## Important information concerning forestay fitting 517-914 (2004 – 2008)

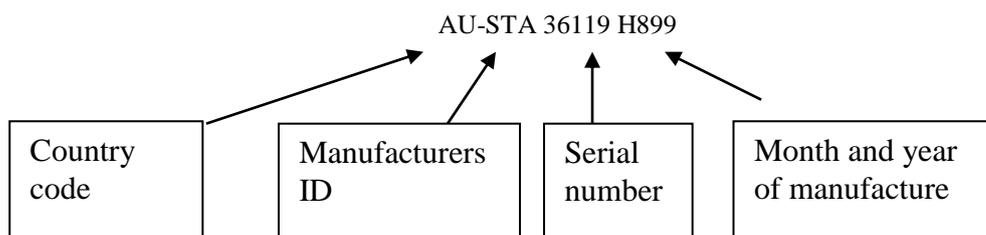
It has been brought to our attention that a few forestay fittings of this design have failed due to a crack in the welding. The crack develops along the weld on the rear side of the fitting inside the mast. It is not visible from the outside. The suspect production batches were used during the period 2004-2008.

All the failed fittings origin from long distance cruising boats with inadequate rig tune and long periods of sailing using only the genoa.

1. Check, before further sailing is done, if your boat is on the list below. If so, please verify that your mast has a forestay fitting marked with the article number 517-914. The number is stamped in the stainless plate and is easy to check from the outside. If your forestay fitting is marked with 517-914-A you already have the improved version and there is no need for a replacement.

2. If that is the case, please fill out and send the [digital form](#) for contacting Seldén.
3. Seldén will immediately deliver a replacement fitting, art no 517-914-90 and decide when and where the replacement will be carried through – naturally in agreement with the owner of the boat.
